Access Compliance Report

Public Rights-of-Way

(Curb Ramps)

Intersection ID: 10176	Main Street: ACADEMY_ST	Cross Street: SPENCER_ST	Location: NW
ADA ID: 4B8B2040B62C	Ramp Type: PerpDiag	Initial Pass/Fail: Fail	Overall Compliance: No
		Severity Score: 12.5

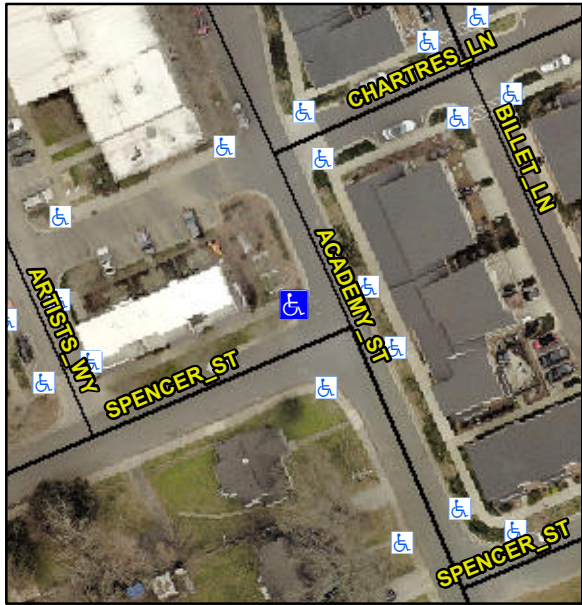
Codes/Mitigation Info/Possible Solution			Field Measurements/Component Compliance					
	Possible Solutions:		Compliance	Description	Data	Compliance	Description	Data
	Remove & Replace Curb Ramp With Two New Directional Ramps or Equivalent.		N/A	Ramp Length (in)	168.0	Yes	Ramp Slope (%)	8.2
			Yes	Ramp Width (in)	48.0	No	Ramp XSlope (%)	6.0
			N/A	Flare Type LT	N/A	N/A	Flare Type RT	N/A
			N/A	Flare Slope LT (%)	N/A	N/A	Flare Slope RT (%)	N/A
			N/A	Flare Traversable LT?	N/A	N/A	Flare Traversable RT?	N/A
			N/A	Landing Length (in)	N/A	N/A	DWS Provided?	N/A
			N/A	Landing Width (in)	N/A	N/A	DWS Contrast?	N/A
			N/A	Landing Slope (%)	N/A	N/A	DWS Length (in)	N/A
			N/A	Landing X Slope (%)	N/A	N/A	DWS Full Width?	N/A
Surveyor Notes:			N/A	Landing Curb? (Y/N)	N/A	N/A	DWS Offset (in)	N/A
PROW/ADA:			N/A	Shared Landing?	N/A			
Not Found, R304.5.3			N/A	Gutter Ponding?	N/A	N/A	Gutter Slope (%)	N/A
			N/A	Gutter Lip Ht (in)	N/A	N/A	Gutter X Slope (%)	N/A

N/A	Painted X Walk1?	No	N/A	Painted X Walk2?	No
				X Walk 1 Direction	To S		X Walk 2 Direction	To E
			N/A	X Walk 1 Width (in)	N/A	N/A	X Walk 2 Width (in)	N/A
				X Walk 1 Slope (%)	6.1		X Walk 2 Slope (%)	1.4
				X Walk 1 X Slope (%)	2.1		X Walk 2 X Slope (%)	7.9
			N/A	Ramp inside XWalk1?	N/A	N/A	Ramp inside XWalk2?	N/A
				Road Slope (%)	6.7	N/A	Clear Space?	N/A
				Road X Slope (%)	6.3	N/A	Clear Space to XWalk (in)	N/A
			N/A	Any Obstructions?	N/A	N/A	Storm Grate/Utility Hazard?	N/A
				Obstruction Type			Storm Grate/Utility Type	
						N/A		N/A
						Yes	Surface Condition? (G/P)	Good
Total Cost:		\$ 3200.00
